PSP 1059. Beveridge North West Precinct Structure Plan

Part A Submission

July 2020

Figure 5 – Walkable Catchments – Proposed Changes

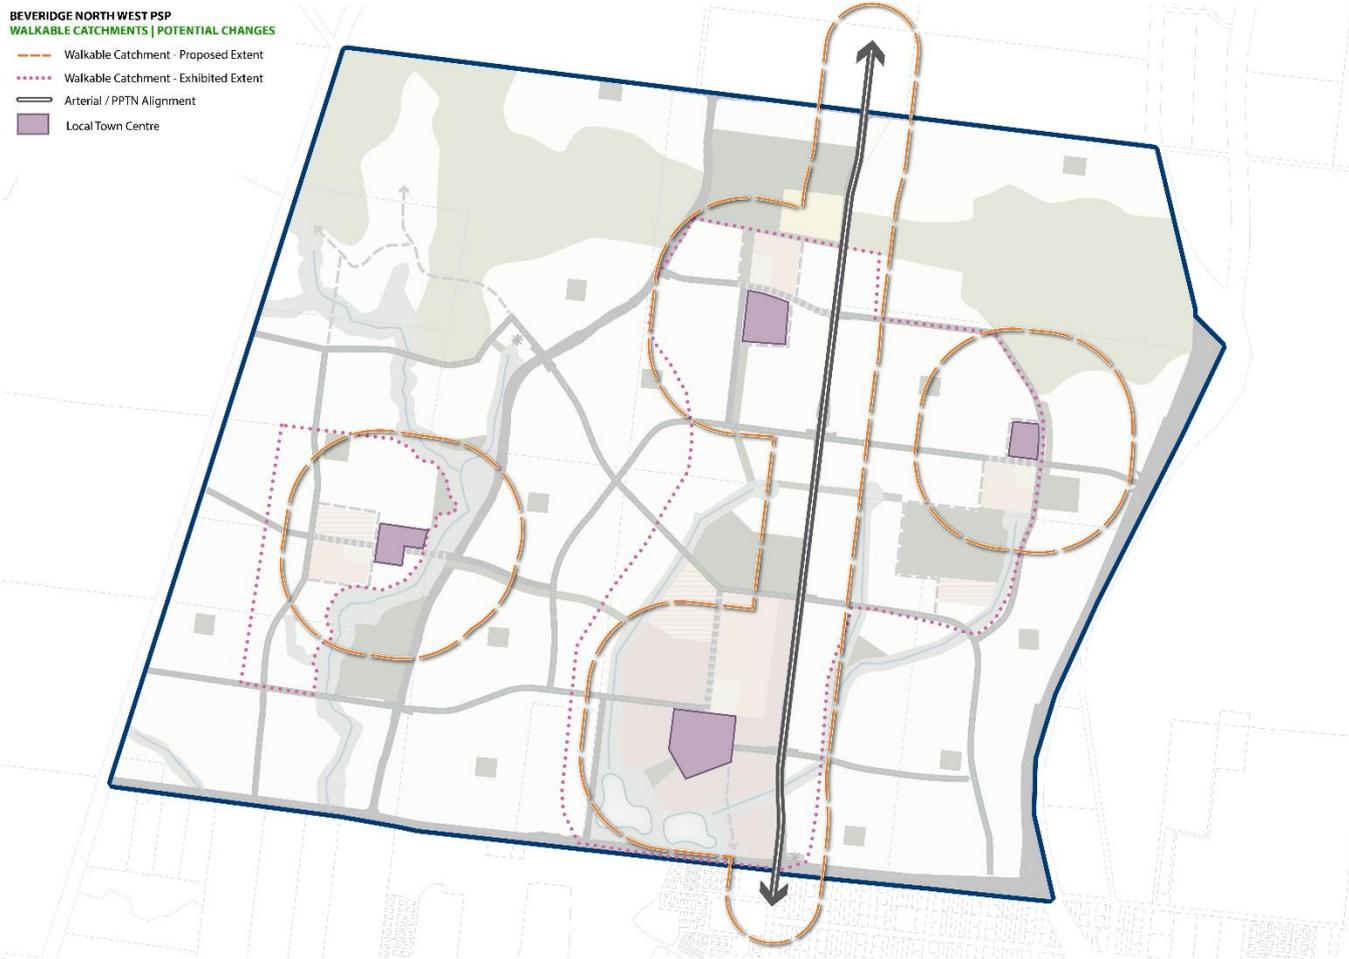
- Amend the extent of the walkable catchments on Plan 3 to reflect a 400m/5min walkable 'ped shed' from future activity centres and the future Principal Public Transport Network (PPTN) (see Figure 5).
- Delete Requirement 2 and 3, and Tables 3 and 4, and replace with proposed Requirement 2 and Table 2.
- Revise the minimum density requirements (provided in the proposed Table 2).
- Consequential amendments to several guidelines.

The amendments to the exhibited extent of walkable catchment is illustrated in **Figure 5** below.

Figure 6 – Local Parks – Potential Changes

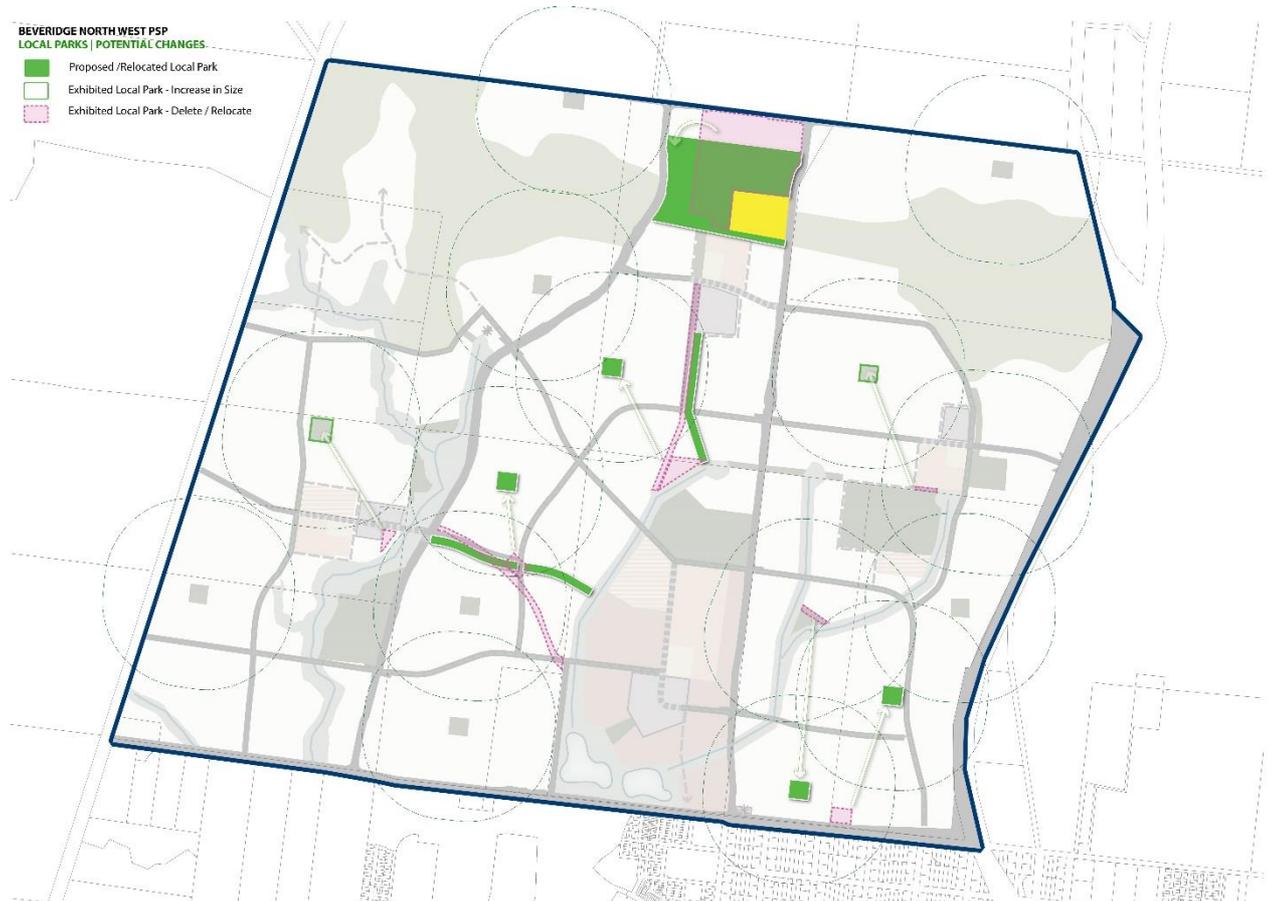
The proposed amendments to locations and sizes of exhibited local parks is indicated in **Figure 6** below to help articulate the changes:

Figure 7 - Bushfire – Potential Changes

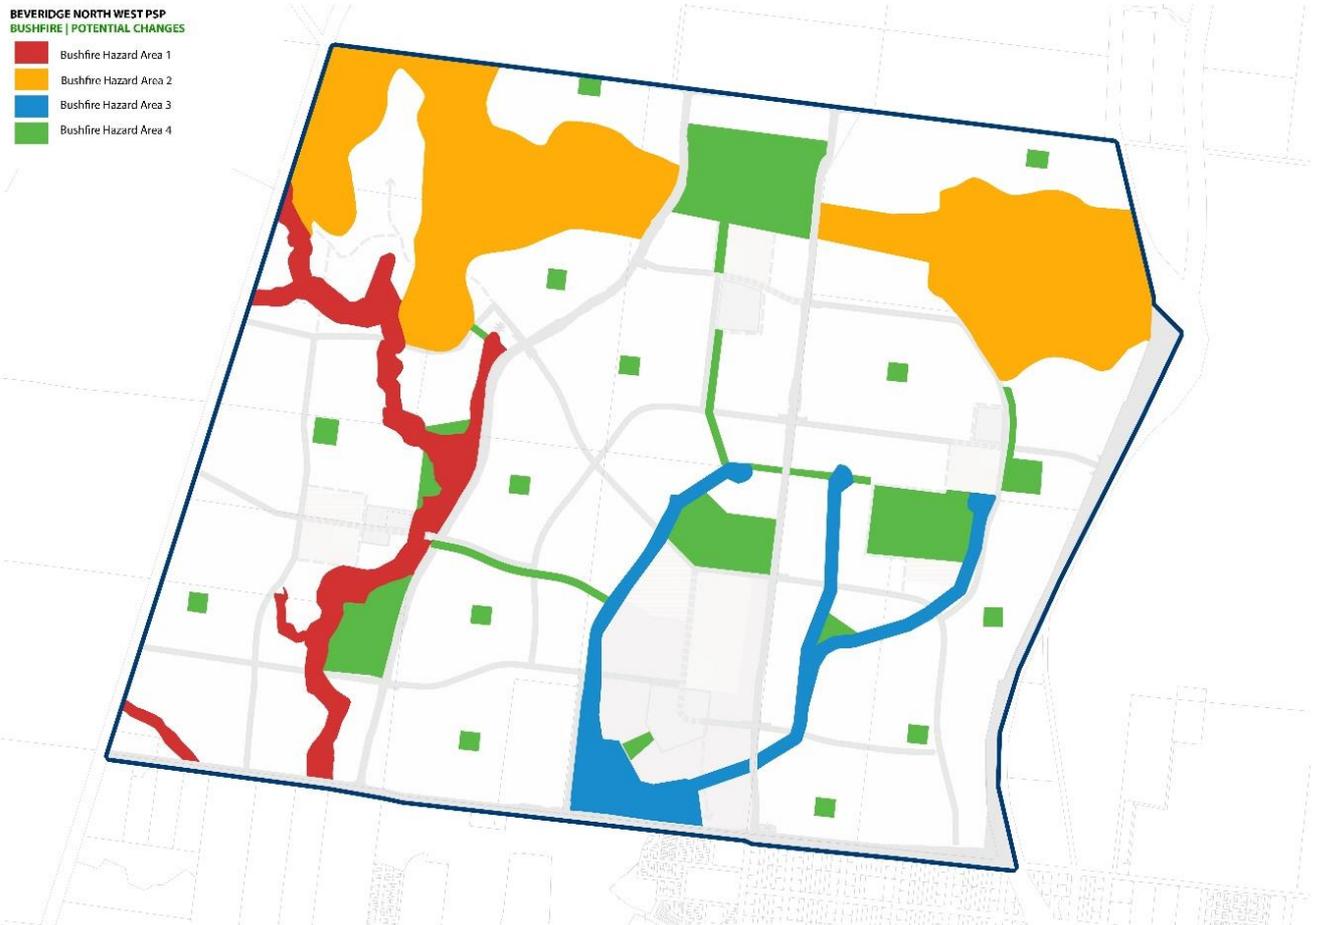
Proposals to amend the bushfire provisions in the exhibited PSP are indicated in the **Figure 7** below:

Figure 9 – Street Network – Potential Changes

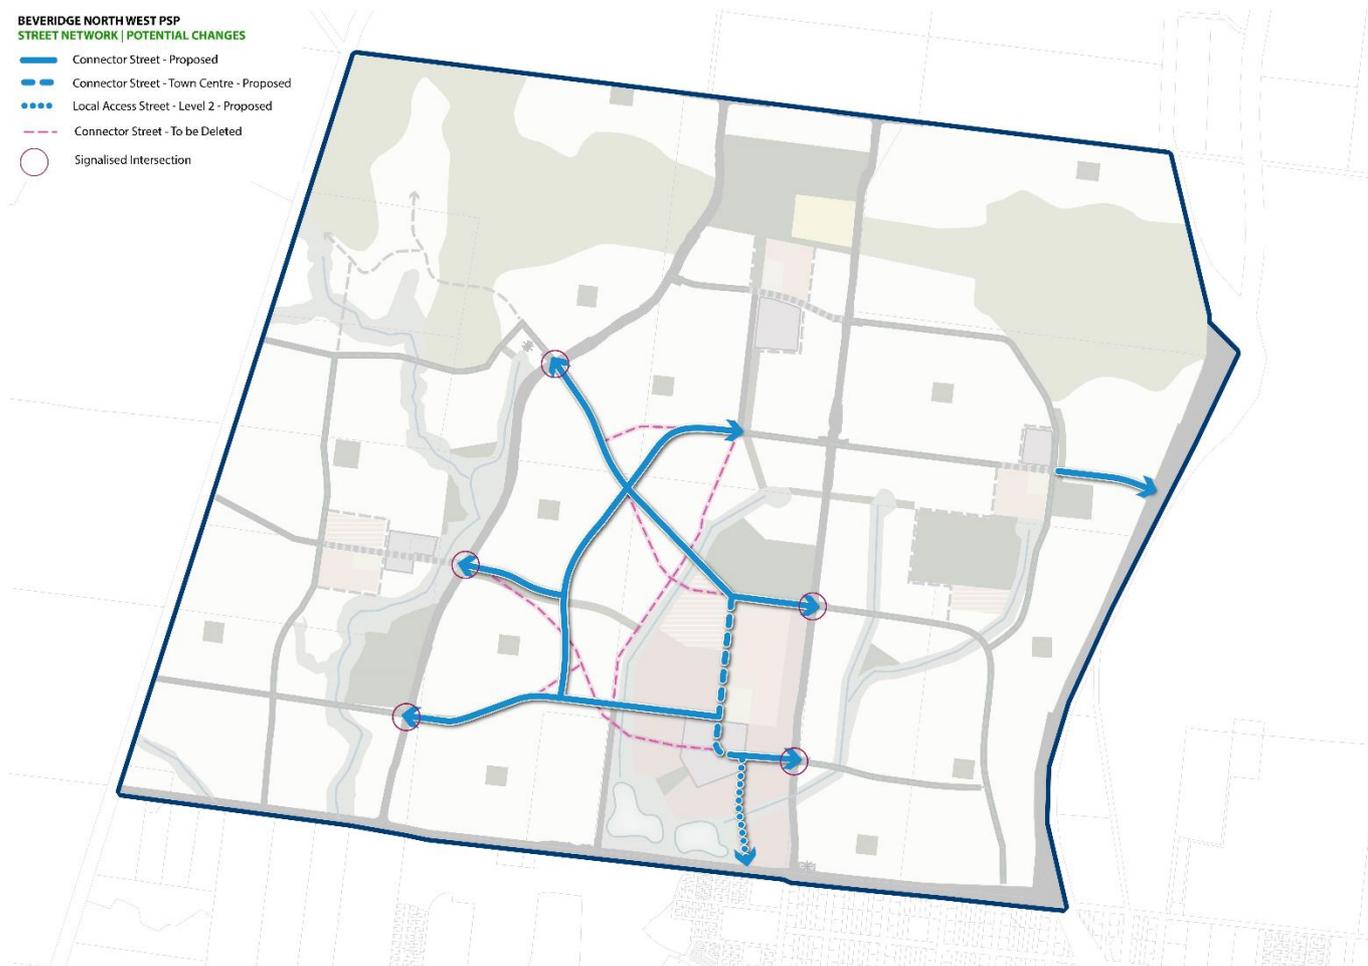
- Relocate the annotation on Plan 9 to a position further north, just south of Spring Hill Cone.
- Addition of the relocated annotation to Plan 10 – Street Network.
- Amendments to the street network shown on **Figure 9** to show a connector street in the relevant location.

Full details of the proposed amendments are included in Section 3.4 of the tracked changes to the PSP document (**Appendix 2**). The potential changes to the street network are indicated in the **Figure 9** below:
